REPLACING PAGE ADDENDUM

**4-WIRE PRIVATE LINE SYSTEM
CONNECTIONS**

1.001 This addendum supplements Section 518-600-400, Issue 1. The attached pages must be inserted in the section in accordance with the filing instructions above.

1.002 This addendum is issued to correct battery and ground connections.

Fig. 3—Typical Connections for a 5-Line, 4-Wire Station Set, Using SSI Selective Signaling and Data Service (Sheet 1)

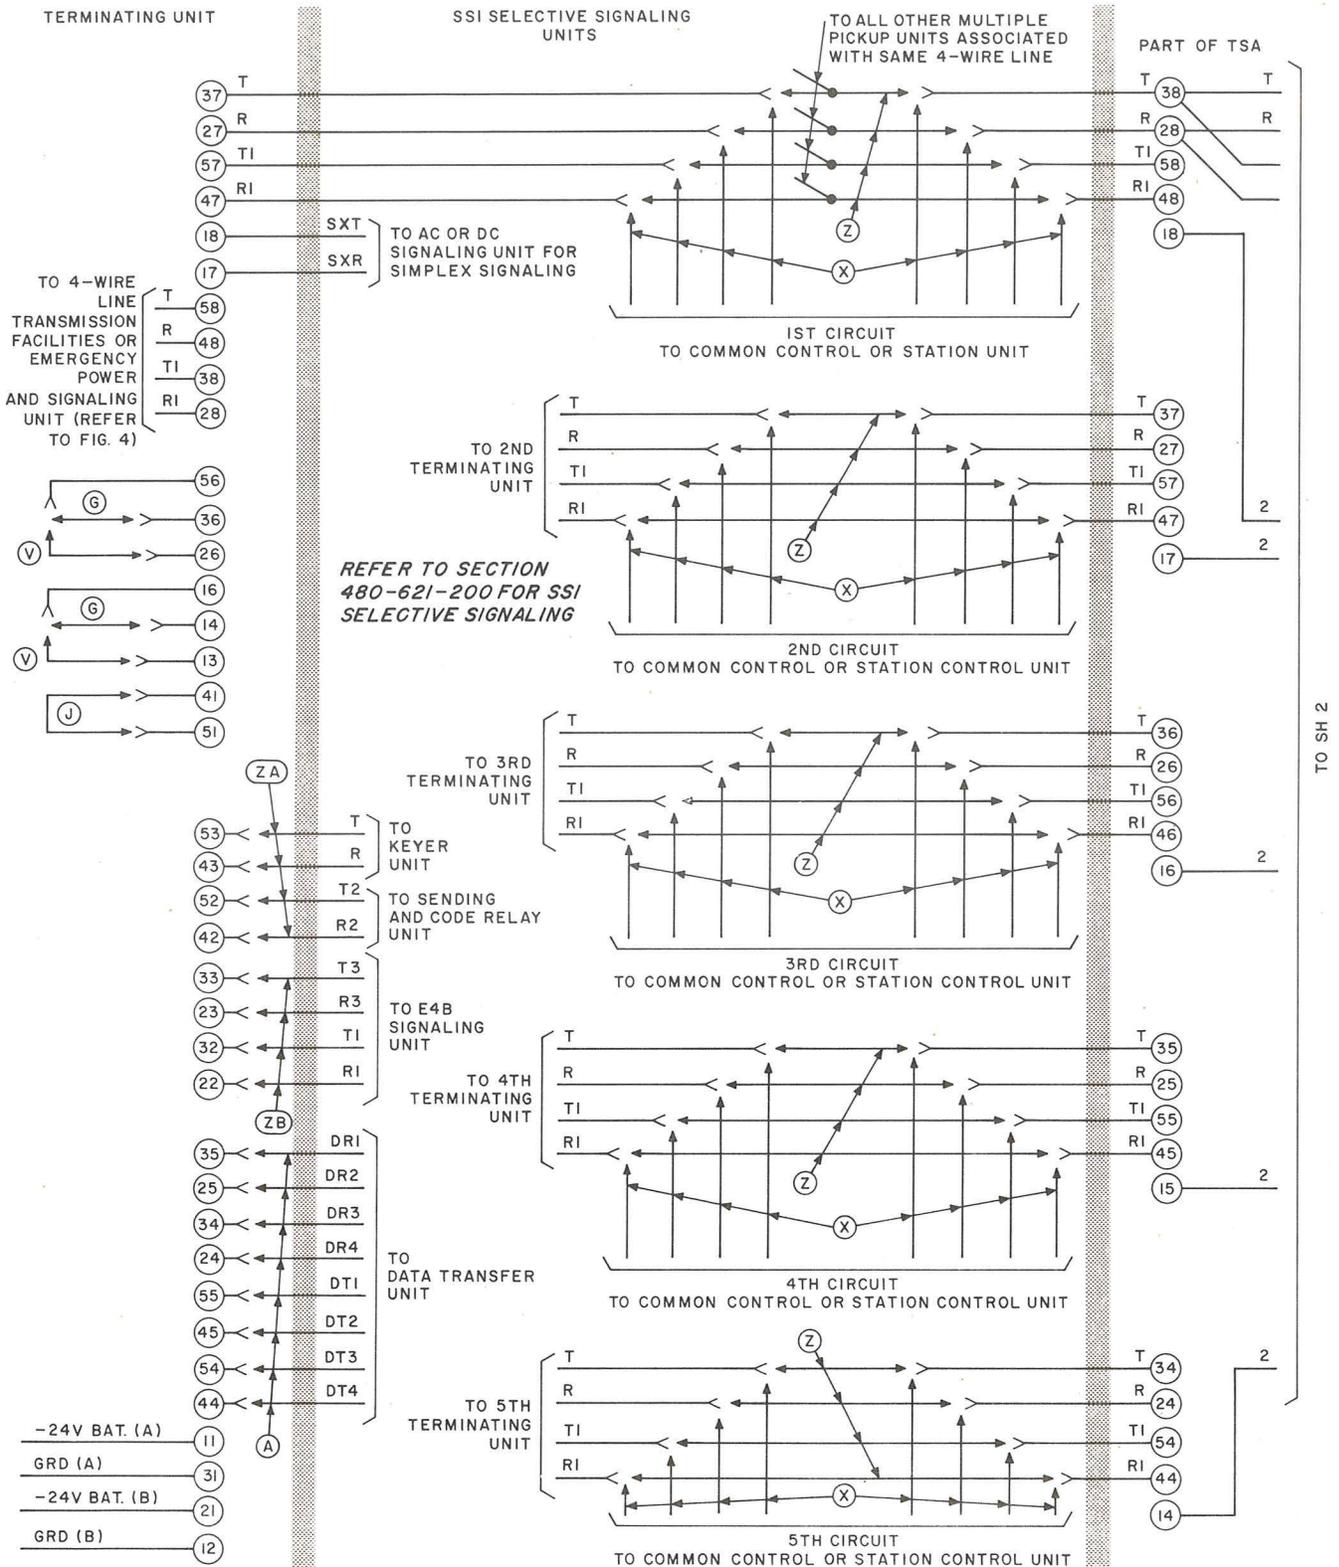
(b) Fig. 3 (Sheet 1), Page 7—revised
